Addendum 3
 Blue Clay Road Business Park
 March 23, 2023

SCOPE: This Addendum No. 3 consists of pages AD3-1 through AD3-2 And covers the following changes to the Project Manual and Bid Drawings.

STANDARD 24" CURB SECTION

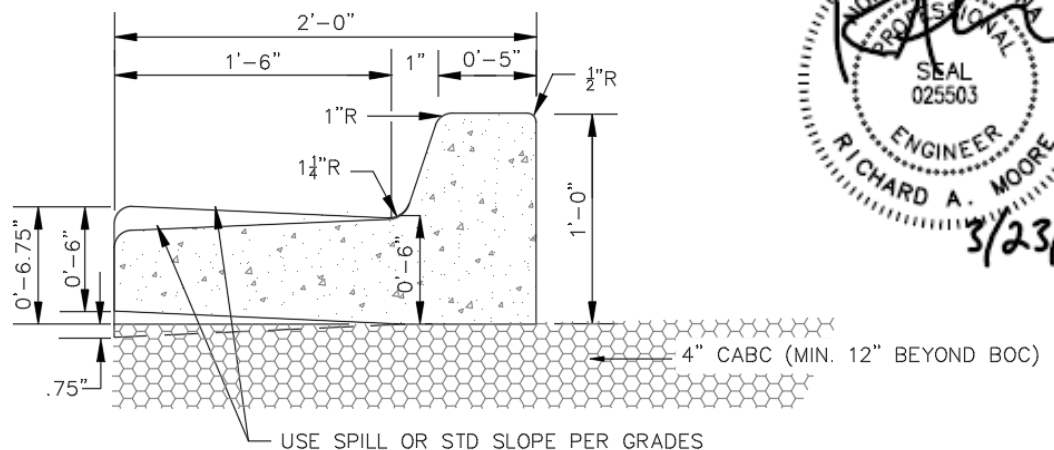
- This is to be bid as a lump sum project.
- Stockpile locations are temporary only. Unsuitable material needs to be disposed of offsite prior to completion of construction.
- Curb and gutter to be used:
